Access Compliance Report

Public Rights-of-Way

(Curb Ramps)

Intersection ID: 29120	Main Street: BEARD_RD	Cross Street: APPLEDALE_DR	Location: S
ADA ID: 16928D0E2B5F	Ramp Type: PerpDiag	Initial Pass/Fail: Fail	Overall Compliance: No
Severity Score: 13.75			
Codes/Mitigation Info/Possible Solution		Field Measurements/Component Compliance

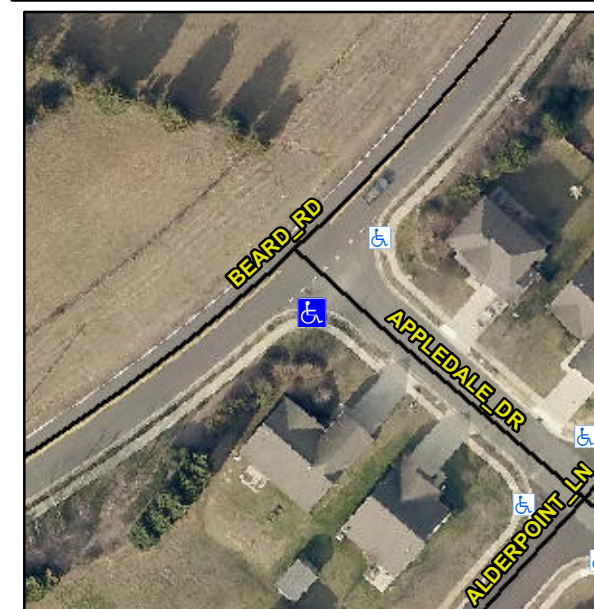
R304.2.2, R304.5.3

Compliance	Description	Data	Compliance	Description	Data
N/A	Ramp Length (in)	41.0	No	Ramp Slope (%)	9.6
Yes	Ramp Width (in)	48.0	No	Ramp XSlope (%)	4.0
N/A	Flare Type LT	N/A	N/A	Flare Type RT	N/A
N/A	Flare Slope LT (%)	N/A	N/A	Flare Slope RT (%)	N/A
N/A	Flare Traversable LT?	N/A	N/A	Flare Traversable RT?	N/A
N/A	Landing Length (in)	N/A	N/A	DWS Provided?	N/A
N/A	Landing Width (in)	N/A	N/A	DWS Contrast?	N/A
N/A	Landing Slope (%)	N/A	N/A	DWS Length (in)	N/A
N/A	Landing X Slope (%)	N/A	N/A	DWS Full Width?	N/A
N/A	Landing Curb? (Y/N)	N/A	N/A	DWS Offset (in)	N/A
N/A	Shared Landing?	N/A			
N/A	Gutter Ponding?	N/A	N/A	Gutter Slope (%)	N/A
N/A	Gutter Lip Ht (in)	N/A	N/A	Gutter X Slope (%)	N/A
N/A	Painted X Walk1?	No	N/A	Painted X Walk2?	No
	X Walk 1 Direction	To NE		X Walk 2 Direction	To NW
N/A	X Walk 1 Width (in)	N/A	N/A	X Walk 2 Width (in)	N/A
	X Walk 1 Slope (%)	2.1		X Walk 2 Slope (%)	2.6
	X Walk 1 X Slope (%)	7.2		X Walk 2 X Slope (%)	3.1

Remove & Replace Curb Ramp With Two New Directional Ramps or Equivalent.
